TULSA METROPOLITAN AREA PLANNING COMMISSION
Minutes of Meeting No. 2494

Wednesday, October 3, 2007, 1:30 p.m.

Spring Hill Farms
SHEET 1 OF 1

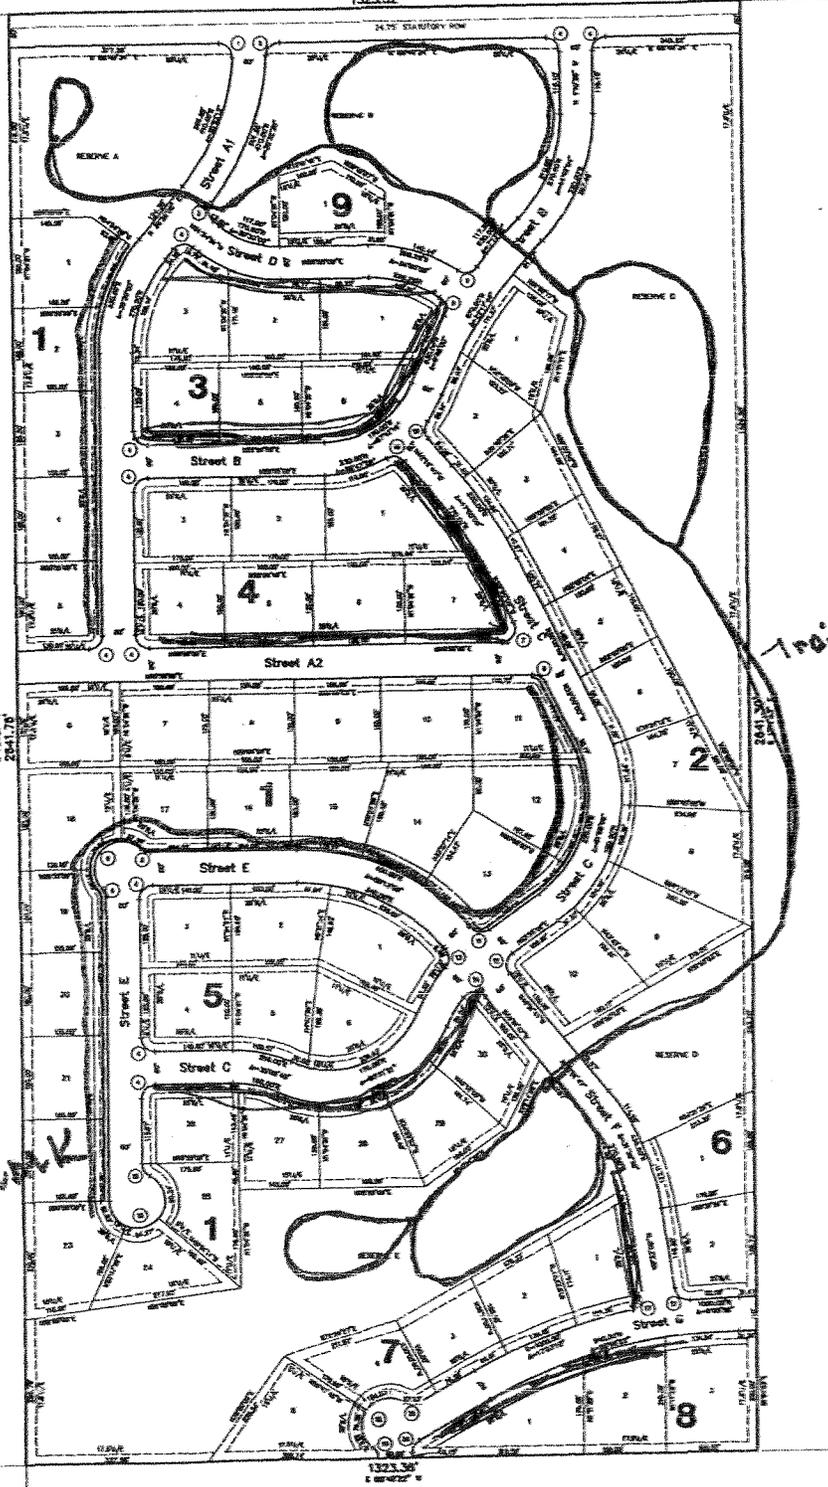
1. **Zoning:** The property is zoned PUD-745 (RS). All PUD conditions must be met. The County Commission has approved the PUD per a trails and sidewalk exhibit (attached) and with a collector street shown for future phases of development (map attached). Trails need to be per transportation planning standards.

2. **Streets:** Show limits of no access restrictions along the Arterial. Discuss four-legged intersection with County Engineer.
3. **Sewer:** Out of service area. Aerobic systems are proposed.

6. **Utilities: Telephone, Electric, Gas, Cable, Pipeline, Others:** This is outside of Cox Cable service area. Additional easements will be needed. Include ONG in covenant standard language. Clarify reserves versus utility easements.

GIS: Please provide the e-mail address for the surveyor. Tie the plat from a section corner using bearings and distances from a labeled point of commencement (POC) to a labeled point of beginning (POB). Give a basis of bearing for the plat's survey using degrees, minutes and seconds.

County Engineer: Show Limits of No Access along north boundary where appropriate. Street names and addresses will be assigned by E-911, to be placed on face of plat. Show "171st Street South" along north edge of plat. Show lot sizes in square footages. Provide driveway culvert sizes on lots or in a table. Restricted water line easement noted in covenants is not shown on plat. Need language to allow utilities in Reserve areas or utility easements across reserves. Change language to reflect public streets. Minimum front yard setback should read "from property line" or should be 55 feet from centerline of street. There are two Section III. Collector design and location to be approved by Tulsa County Engineer. Sidewalks will be needed to access trail system. May need access easements or extension of Reserves between lots to provide access to trails at appropriate locations, depending on sidewalk plan. Need drainage easements between Lots 4, 5, 8 and 9, Block 2, and between lots 28 and 29, Block 1. Drainage easement locations may be a good place to combine access to trails, if needed.

1. A waiver to standard sidewalk requirements is needed per the approved trails/sidewalk plan.

Ms. Cantrell stated that there are places within the proposal where there are no sidewalks except to get to the trails and some would have to walk in the street for a good distance before accessing the trail with the plan that Mr. Jones is proposing.

Ms. Cantrell stated that she agrees with using the trail, but she doesn't believe that there are enough sidewalks for adequate pedestrian circulation. In response, Mr. Jones stated that Mr. Jordan was adamant about not wanting a sidewalk on 171st Street. Mr. Jones indicated that Mr. Jordan stated that when a

Mr. Jones stated that if the sidewalk plan needs to be modified then he would be willing to work on it and go back to the County Engineers with it. In response, Mr. Ard stated that he agrees with Ms. Cantrell that there are not enough sidewalks for the pedestrian circulation. Mr. Ard commented that he appreciates the trail system, but he believes there are some additional streets that need sidewalks. Mr. Ard commented that there should be a plan for every lot to have access to a sidewalk or the trail because that would give pedestrian circulation to every lot and that is what the Planning Commission is charged with.

Mr. Midget stated that there is a similar situation on Cincinnati and the borrow ditch is closer to the street and the sidewalk is on the other side of it. It is possible for the subject site to be designed the same way and it is safer for the pedestrians. Mr. Midget demonstrated where other sidewalks should be located in order to give more lots access to the trail system. In response, Mr. Jones stated that he believes that his developer would be in agreement with Mr. Midget's proposal, but he would like to condition it upon the County Engineer's approval. Mr. Jones expressed concerns that his plans are already submitted to the County, but if the Planning Commission is in agreement with the modifications that Mr. Midget has proposed he will walk it over to the County today. See additional sidewalks on exhibit (2.d.8) below represented in red:

Mr. Ard asked staff if they believe there should be a sidewalk along the arterial. In response, Mrs. Fernandez stated that she believes there should be a sidewalk along the arterial. However, when it should be installed she can't determine. It is her understanding that the County Engineer wants to put the sidewalks in after the roadway is improved. Her opinion is that sidewalks are needed along the arterial streets. She suggested that the Planning Commission could approve the plan with the additional sidewalks suggested by Mr. Midget. Staff can

recommend approval of the plan with the additional sidewalks suggested by Mr. Midget.

Mr. Ard asked Mr. Jones if he was in agreement with the suggestions of Mr. Midget regarding sidewalks and verbiage relating to the arterial sidewalks being installed by the County in the covenants. In response, Mr. Jones stated that he is in agreement with these conditions.
